Product Change Notification / RMES-11GYOB585

CCB 4854 Final Notice: Qualification of ATP7 as an additional assembly site for Microsemi PD69104xx and PD69108xx device families available in 48L VQFN (8x8x1.0mm) package.

CCB 4854
Pre and Post Change Summary
PCN #: RMES-11GYOB585

NSEB

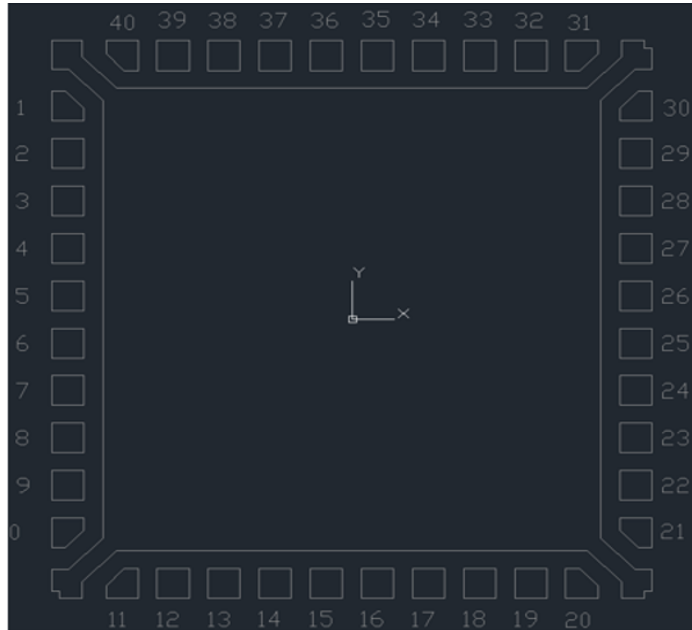
Lead Frame Material	EFTEC-64T
DAP Surface Prep	Spot Plating (Ag on lead only)

ATP7

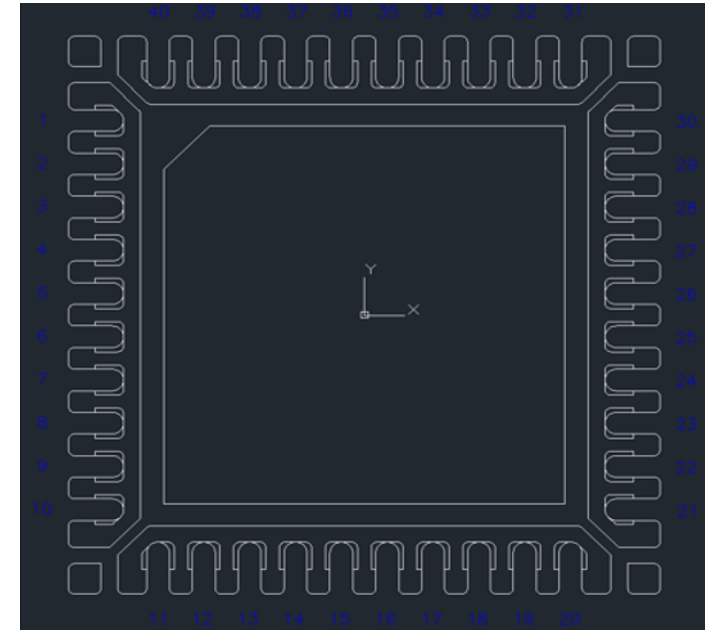
Lead Frame Material	C194 FH
DAP Surface Prep	Ring Plating
